Access Compliance Report

Public Rights-of-Way

Intersection ID: 12869	Main Street: E_TRADE_ST	Cross Street: N_ALEXANDER_ST	Location: N
ADA ID: 56CF29F27DDA	Ramp Type: ParaDiag	Initial Pass/Fail: Fail	Overall Compliance: No
			Severity Score: 13.75

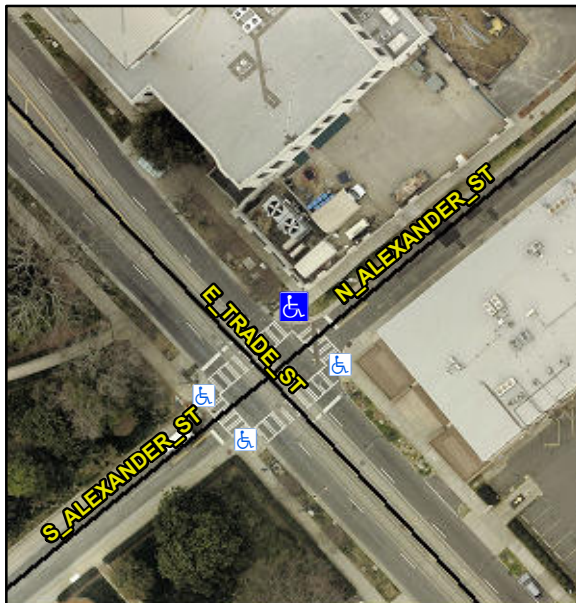
R304.3.2, R304.5.3

Compliance	Description	Data	Compliance	Description	Data
N/A	Ramp Length LT (in)	57.0	N/A	Ramp Length RT (in)	53.0
Yes	Ramp Width LT (in)	60.0	Yes	Ramp Width RT (in)	61.0
Yes	Ramp Slope LT (%)	5.6	No	Ramp Slope RT (%)	10.3
Yes	Ramp XSlope LT (%)	1.1	No	Ramp XSlope RT (%)	2.5
N/A	Landing Length (in)	N/A	N/A	DWS Provided?	N/A
N/A	Landing Width (in)	N/A	N/A	DWS Contrast?	N/A
N/A	Landing Slope (%)	N/A	N/A	DWS Length (in)	N/A
N/A	Landing X Slope (%)	N/A	N/A	DWS Full Width?	N/A
N/A	Landing Curb? (Y/N)	N/A	N/A	DWS Offset (in)	N/A
N/A	Shared Landing?	N/A			
N/A	Gutter Ponding?	N/A	N/A	Gutter Slope (%)	N/A
N/A	Gutter Lip Ht (in)	N/A	N/A	Gutter X Slope (%)	N/A
N/A	Painted X Walk1?	Yes	N/A	Painted X Walk2?	Yes
	X Walk 1 Direction	To SW		X Walk 2 Direction	To SE
N/A	X Walk 1 Width (in)	111.0	N/A	X Walk 2 Width (in)	112.0
	X Walk 1 Slope (%)	7.4		X Walk 2 Slope (%)	6.8
	X Walk 1 X Slope (%)	4.8		X Walk 2 X Slope (%)	8.9

Remove & Replace Curb Ramp With Two New Directional Ramps or Equivalent.
